Docket Item #11 SPECIAL USE PERMIT #2003-0115

Planning Commission Meeting September 9, 2004

301 Laverne Avenue

SUP#2003-0115, SUBSTANDARD LOT DEVELOPMENT

Design

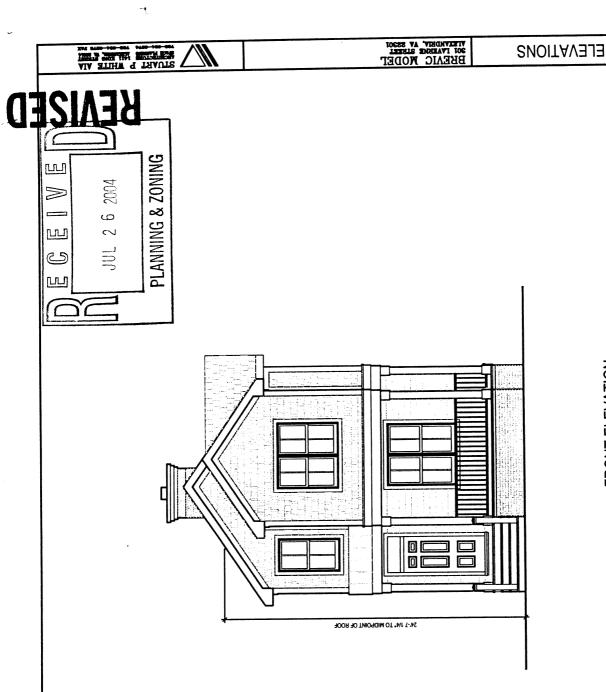
The applicant's revised plan attempts to respond to some of staff's design concerns. The applicant reduced the length of the house by seven feet in response to staff's concern about the length of the house relative to the small lot. However, it is still too long for the property, and the revisions also widened the house by three feet, which staff does not support because of the narrowness of the lot. Furthermore, the change to the footprint includes a reduction in size and prominence of the front porch, a critical element of a Del Ray house. Regarding the driveway, the applicant proposes two standard parking spaces to address staff's concern regarding a parking reduction. However, the wider driveway takes away usable open space in the rear yard, will result in the removal of significant trees in the rear yard, and would have to be longer than what is depicted on the plan in order to meet the minimum parking space size and prevent overhang into the right-of-way. It is unclear whether the applicant explored other drive options to save the trees. An unfortunate result of the changes to the plans are the elevations. The Turner Road facade, while proposing smaller cantilevered windows, is overly complex for a Del Ray house. In addition, the windows along this facade, and others, lack order in their arrangement.

LaVerne Avenue Facade

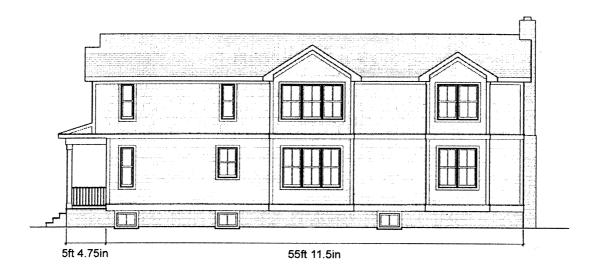
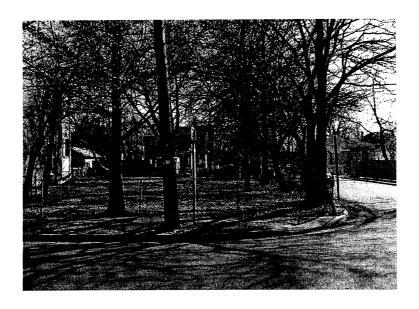
simplified New-Colonials. Although the style of the proposed house is not a common type in the area, it resembles a Folk Victorian, and although not exact, is an attempt to evoke the historic context of the area. The front porch on the proposed house is a common element in the district, although the slight overhang of the second floor is not typically seen on the historic homes. The length of the proposed house, particularly compared to the smaller lot size, is not demonstrated in the historic homes in the neighborhood. Although houses technically can develop to a .45 floor area ratio, the historic homes were originally developed at much less, and allowable additions are generally made to look subordinate to the original structure. In this case, the applicant maximized the floor area ratio in the original structure, making the main structure less compatible with the historic context.

The applicant's design has significantly improved over several iterations in response to staff's numerous concerns with the application. The initial design was boxy and windowless on the street side showing little consideration for the corner location. Windows on the other facades of the house were awkwardly placed in a disorganized way. Additionally, the proposal removed most of the trees that line the property. The final design being proposed here is more attractive, with windows on the street side, arranged in an organized manner. However, the house is awkwardly long and narrow, extending well beyond the rear wall of the adjacent semi-detached dwelling. The 60 foot long front wall along Turner is oppressively close to the street and lacking in detail in the design. The cantilevered windows on Turner Road are oversized and emphasize the excessive length. The narrowness of the house may be partly responsive to staff's concern about the mature trees, but since the trees cannot be saved regardless, the house design would have to be significantly different to better fit the lot.
